Proposed 2021 New York City Fire Code: NYSEIA Comments

June 10, 2021

Figure 2: Impact of Proposed Window Setback Zone on Usable Solar Roof Space

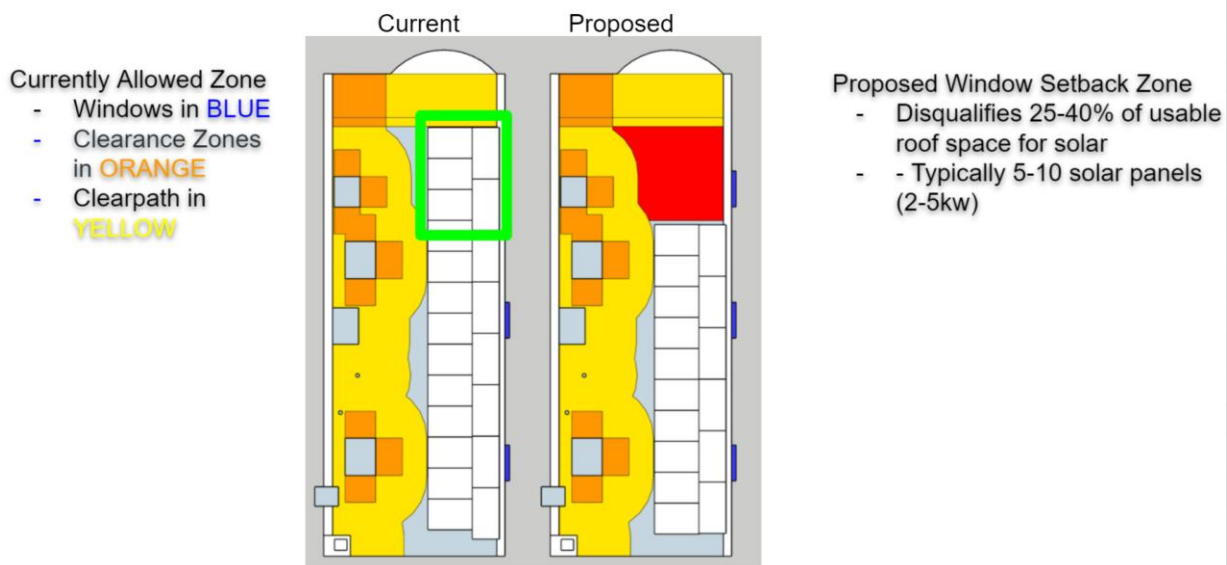
NYSEIA strongly recommends removing the new requirement to provide a clear path on 30 percent of the wall area for rear yards and side walls with windows. Based on member firms' studies of several buildings, we find that this requirement will reduce the potential solar PV capacity of the roof by as much as 20 percent for typical buildings with 5-200 kW-DC systems, which constitute the vast majority of the addressable market in New York City. Overall, as shown in Figure 2, the proposed window setbacks would reduce 25 to 40 percent of usable roof space for solar, translating to a reduction of five to ten solar panels on a typical 20 x 40 ft building. As panel efficiency and therefore wattage increases over time, this capacity loss will only increase further. Furthermore, fixed costs for such projects tend to be high, meaning that system prices per watt would also increase significantly and degrade their value proposition for potential customers.
